RESPONSES TO
NRC QUESTIONS
ON THE
MONTICELLO PUAR

PREPARED BY
NUTECH ENGINEERS, INC.
SAN JOSE, CALIFORNIA

PREPARED FOR
NORTHERN STATES POWER CO.

NRC QUESTION ON MONTICELLO PUAR
HYDRODYNAMIC LOAD RESPONSE

Figure 15 - 6" ϕ

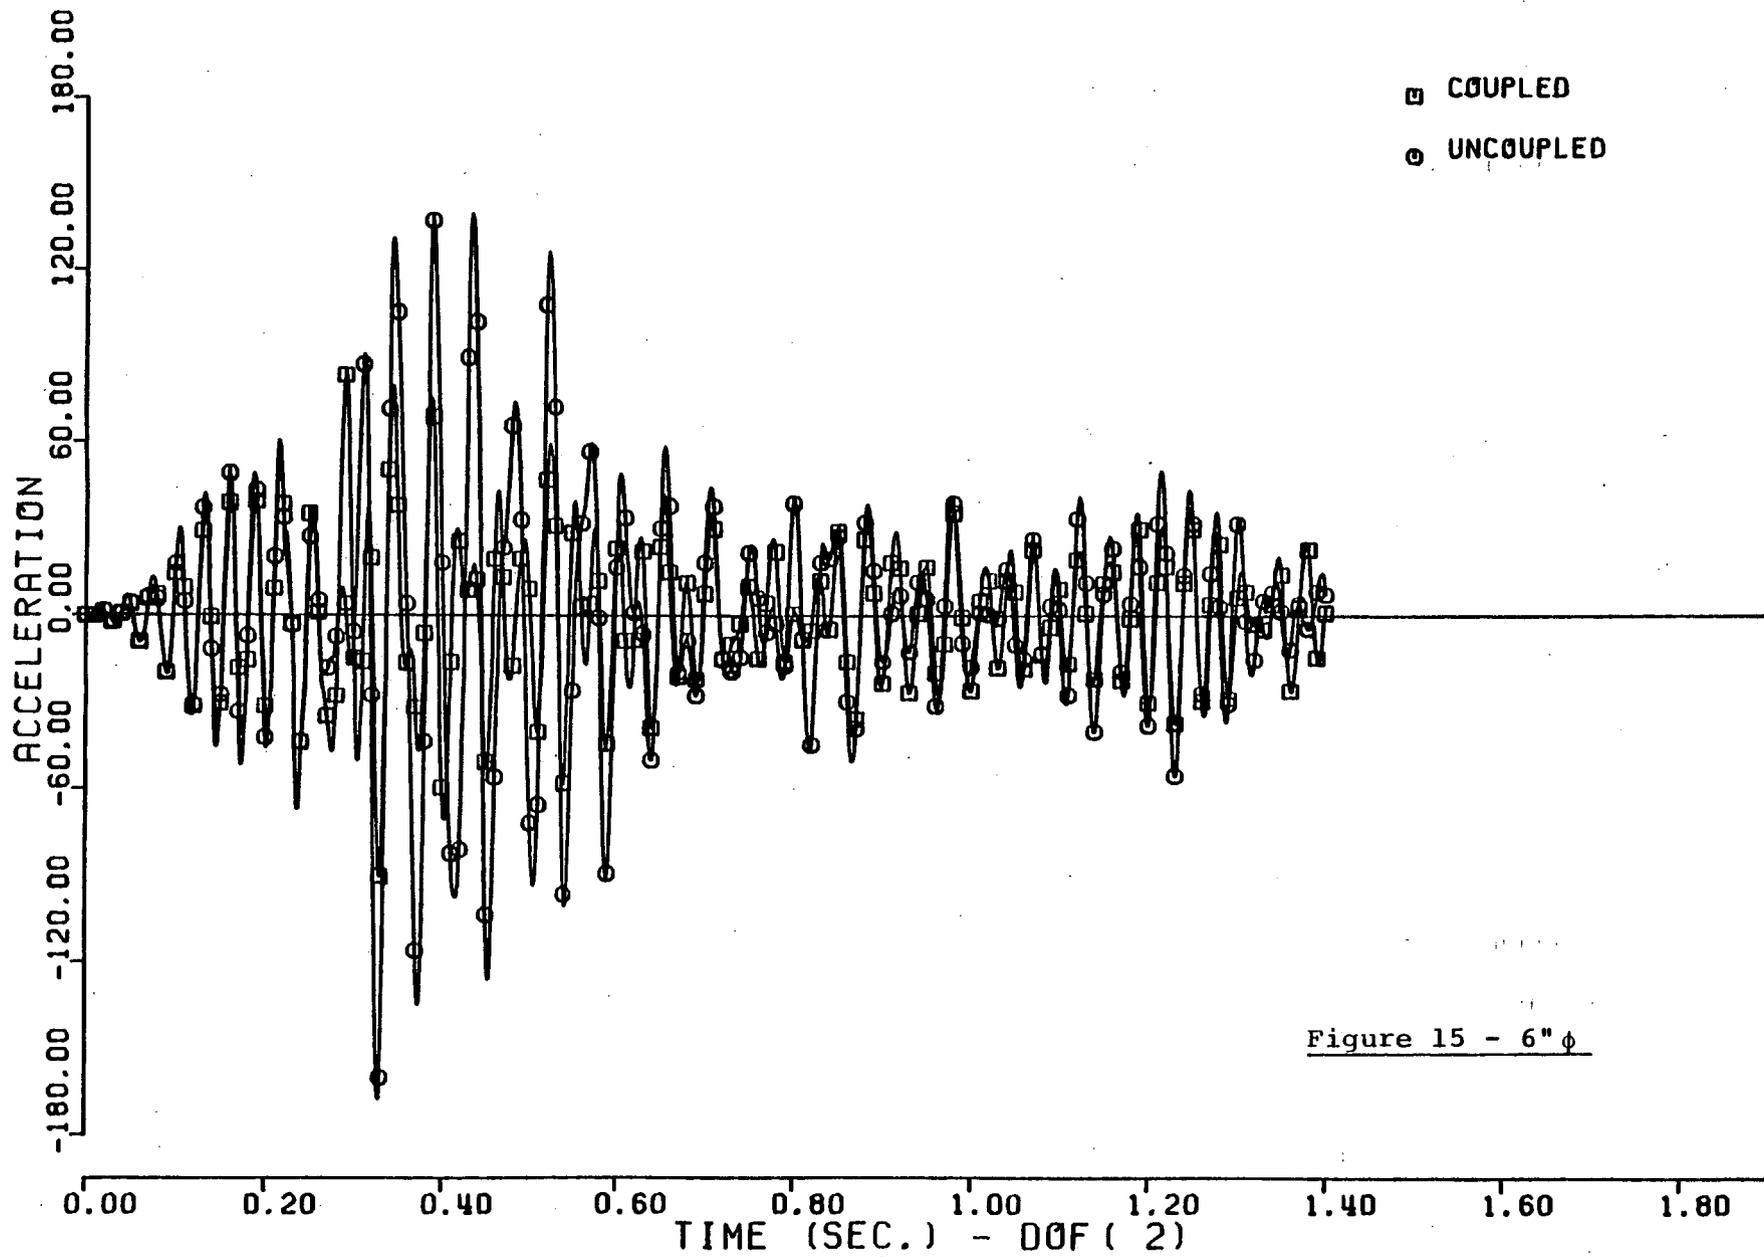
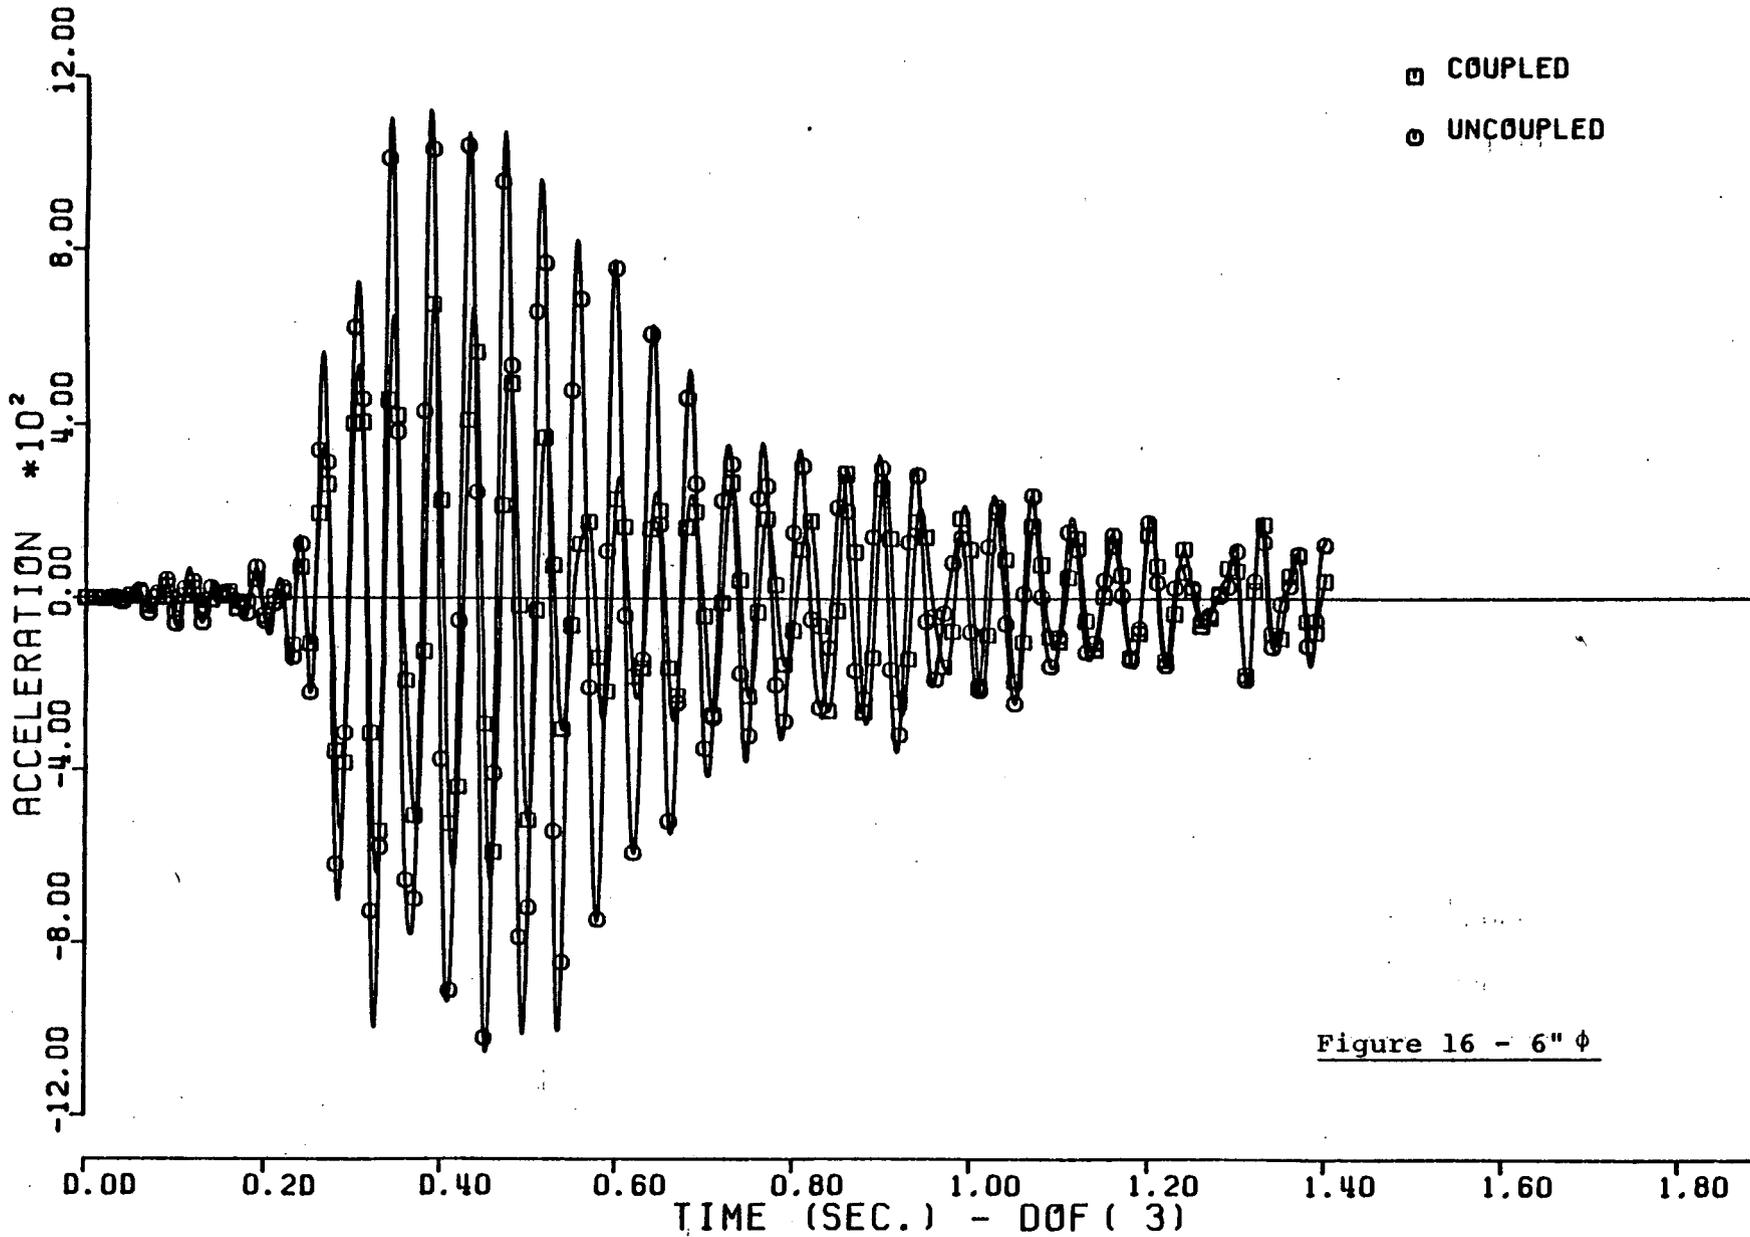
ITEM 12: The computer code CMDOF has been used in the torus attached piping analysis for all plants that utilized NUTECH as their contractor. With regard to the code provide the following information:

- 1) Theoretical background of CMDOF computer program
- 2) Program verification
- 3) Applicability of the computer program to the torus attached piping analysis.

To illustrate the effect of pipe size on coupling, four typical piping systems were examined and the coupled and uncoupled time histories plotted together. These time histories include both the smallest (2") and larger (20") systems analyzed. Listed below are the figure numbers and the corresponding line size.

Figure 4-8	2" diameter
9-13	4" diameter
14-18	6" diameter
19-21	20" diameter

These plots confirm the expected variation of coupling benefit with pipe size.
